1 INTRODUCTION

NPTC Highways Response

PLANNING APPLICATION NO: 2/3/24/0194/00

MUGA ADJACENT TO AFAN LIDO FOOTBALL CLUB, THE PRINCESS MARGARET WAY, ABERAVON

FIGURE 2.2: PROPOSED PEDESTRIAN ROUTE WITHIN CAR PARK

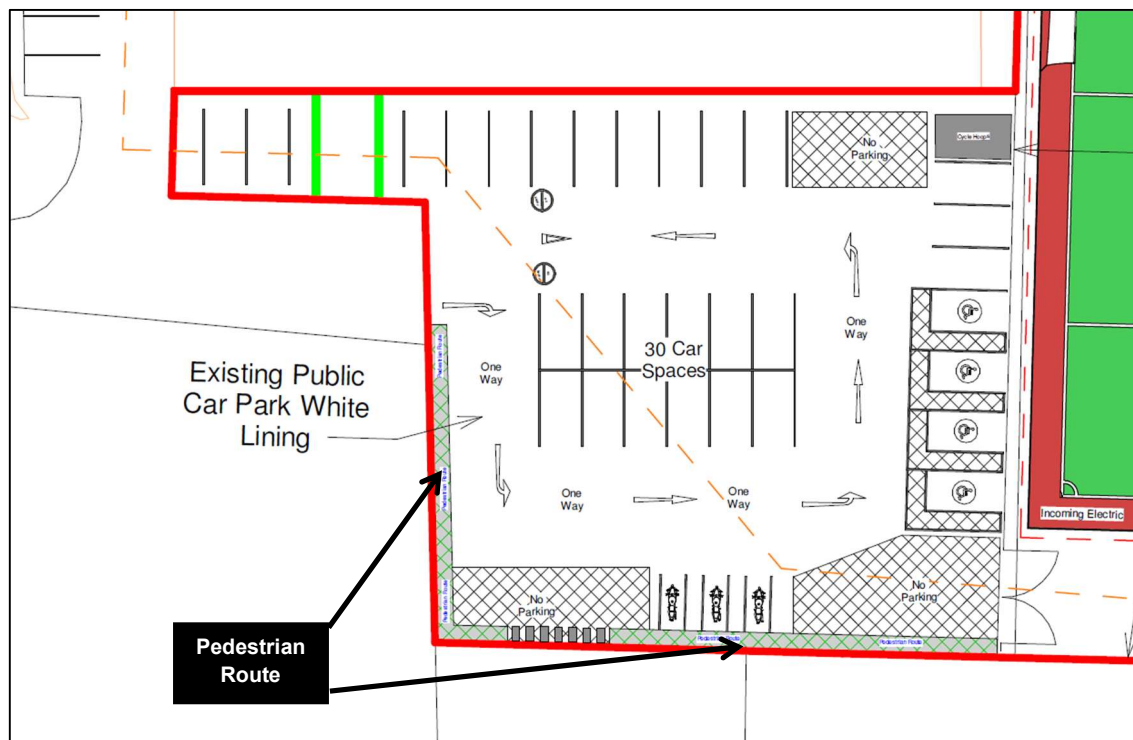
- All proposed pedestrian access routes to the development should be clearly annotated on a plan. Will pedestrians attending the site via foot have access through the car park? If so, provisions should be made for a designated pedestrian route through the carpark area in accordance with Active Travel requirements to avoid pedestrian-vehicle conflict.
- Will there be 100 or 150 seats in the stand. This has a material impact on the levels of parking required and the impact of the development on the surrounding highway network. Our assessments will be based on 150 seat capacity as a worst case scenario assessment unless you state otherwise. Parking associated with the clubhouse should also be considered in any parking assessment.

- 2.2 Section 4.9 of the TSTP identifies that pedestrian access will be via the vehicular access, which is already used by pedestrian associated with the bowls club and Afan Lido FC, as well as from a new pedestrian only access on Moorland Road in the northern corner of the site.
- 2.3 A drawing showing a 1.2m pedestrian route around the car park has been prepared by GO Concept Designs and is attached as **Appendix B** and shown below in **Figure 2.2**.

- 2.4 This has been achieved by relocating the motorcycle spaces but does not affect the vehicle tracking. However, two parking spaces are lost and so a total of 30 spaces is now proposed.
